802-822 W.
Streetsboro St.

Concept Site Plan – Day
Care Center

Hudson Planning Commission	CONCEPT SITE PLAN REVIEW – DAY CARE
Case No. 26-73	March 9, 2026

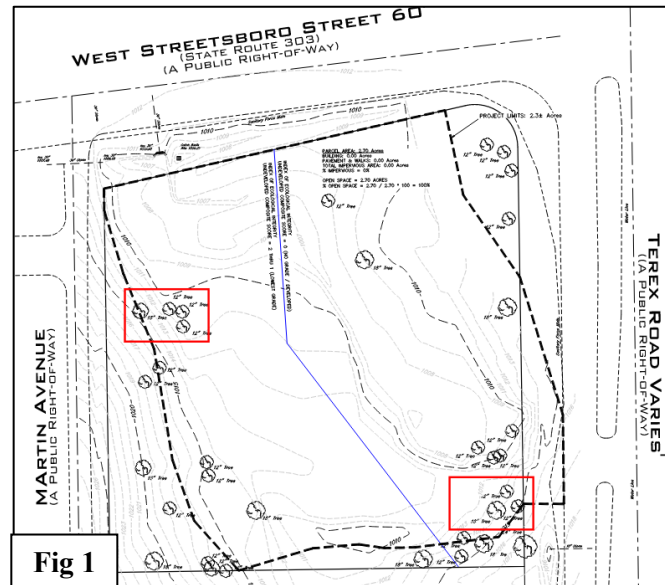
Section 1207.18(b)(5) - Tree Protection: Staff notes there is opportunity to preserve existing trees on the south and west sides of the property abutting Martin Drive properties. Question if additional trees can be preserved along the areas highlighted in Figure 1.

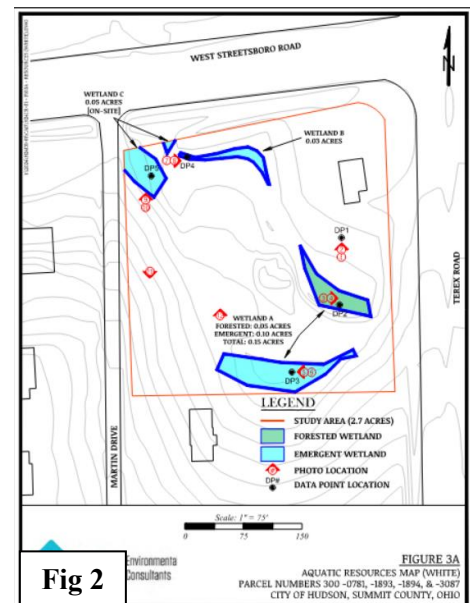
Section 1207.18(b)(6) - Wetlands/Stream Corridor Protection: Staff notes there are three wetlands onsite. These are labeled A, B, and C in Figure 2. These wetlands have been identified in the City's Index of Ecological Integrity, though have scored under the lowest composite. The applicant proposes the following:

1. Convert Wetlands B and C along W. Streetsboro St. into a stormwater pond.
2. Fill the portion of Wetland A that is located in the center of the property in order to construct the parking lot.
3. Regrade the majority of the portion of Wetland A that is located along the southern property line.

- Question the current category of the wetlands. Within District 6 and 8, the LDC requires a 100 ft setback for Category II and III wetlands and no setback for Category I. Category I wetlands are low-quality wetlands with minimal ecological functions. Staff understands Category I wetlands were once present on the site based on previous approvals.

- Staff notes grading work was conducted on the property in 2020 under previous Army Corp of Engineers authorization to fill .076 acres of Category I wetlands. The applicant has submitted a current approval from the Army Core of Engineers for the proposed work; however, the letter states the approval expires on March 14, 2026.

- Question if the southern portion of Wetland A could be preserved by shifting the proposed improvements closer to W Streetsboro Street. This would also provide additional natural buffer between the residential property to the south. Staff has reviewed the applicable setbacks further following the pre-application meeting and determined a 50 ft building setback and 25 ft parking lot setback can be applied along the W. Streetsboro St. frontage.

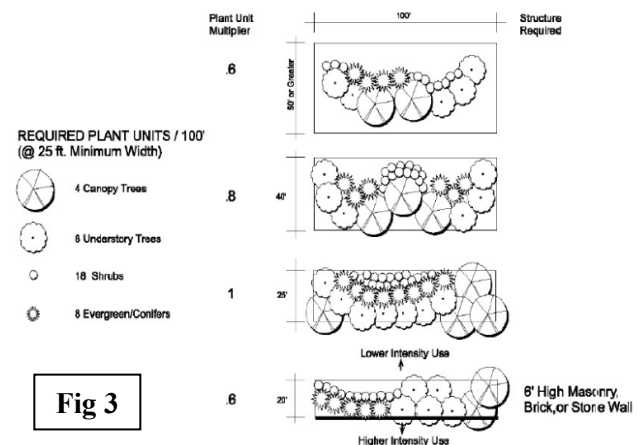
- A landscape Bufferyard D (See Figure 3 below) shall be installed along the side and rear boundaries of the development adjacent to residentially zoned or used property. Staff notes this bufferyard may be expanded based on the conditional use criteria. Additional trees may count towards the requirement. Question how the bufferyard would be established along the southern property line to meet this requirement.
